Access Compliance Report

Public Rights-of-Way

(Curb Ramps)

Intersection ID: 29798	Main Street: RUDOLPH_DADEY_DR	Cross Street: SMART_LN	Location: W
ADA ID: 25273CA0392A	Ramp Type: PerpDiag	Initial Pass/Fail: Pass	Overall Compliance: No
Severity Score: 10.25			
Codes/Mitigation Info/Possible Solution		Field Measurements/Component Compliance

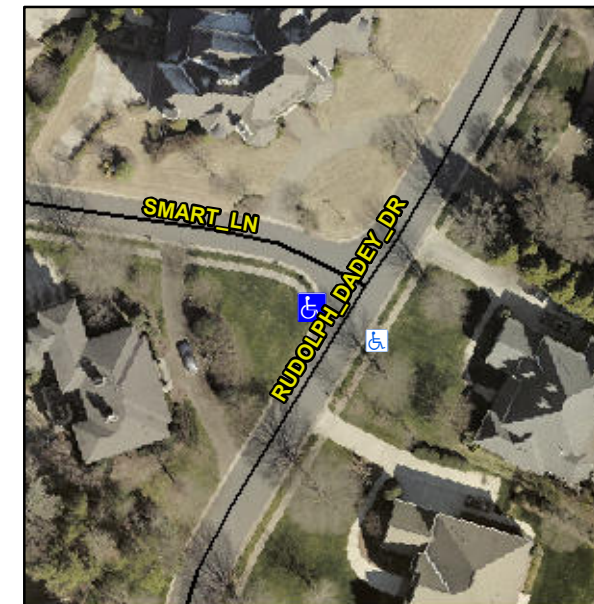
Not Found, R304.5.3, R304.2.1, R304.2.2-Perp, R304.3.2-Para, R305

Compliance	Description	Data	Compliance	Description	Data
N/A	Ramp Length (in)	48.0	Yes	Ramp Slope (%)	5.3
Yes	Ramp Width (in)	48.0	No	Ramp XSlope (%)	4.4
N/A	Flare Type LT	Sloped	N/A	Flare Type RT	N/A
N/A	Flare Slope LT (%)	5.0	N/A	Flare Slope RT (%)	2.7
N/A	Flare Traversable LT?	No	N/A	Flare Traversable RT?	No
No	Landing Length (in)	46.0	No	DWS Provided?	No
Yes	Landing Width (in)	48.0	N/A	DWS Contrast?	No
No	Landing Slope (%)	2.5	N/A	DWS Length (in)	N/A
Yes	Landing X Slope (%)	1.1	N/A	DWS Full Width?	No
N/A	Landing Curb? (Y/N)	No	N/A	DWS Offset (in)	N/A
N/A	Shared Landing?	No			
Yes	Gutter Ponding?	No	Yes	Gutter Slope (%)	1.5
Yes	Gutter Lip Ht (in)	0.0	No	Gutter X Slope (%)	3.3
N/A	Painted X Walk1?	No	N/A	Painted X Walk2?	No
	X Walk 1 Direction	To SE		X Walk 2 Direction	To NE
N/A	X Walk 1 Width (in)	N/A	N/A	X Walk 2 Width (in)	N/A
	X Walk 1 Slope (%)	3.2		X Walk 2 Slope (%)	1.5
	X Walk 1 X Slope (%)	0.2		X Walk 2 X Slope (%)	5.3

N/A	Ramp inside XWalk1?	N/A	N/A	Ramp inside XWalk2?	N/A
	Road Slope (%)	1.7	N/A	Clear Space?	Yes
	Road X Slope (%)	7.1	N/A	Clear Space to XWalk (in)	N/A
Yes	Any Obstructions?	No	Yes	Storm Grate/Utility Hazard?	No
	Obstruction Type			Storm Grate/Utility Type	
		N/A			N/A
			Yes	Surface Condition? (G/P)	Good

Remove & Replace Curb Ramp With Two New Directional Ramps or Equivalent. Remove & Replace Gutter.
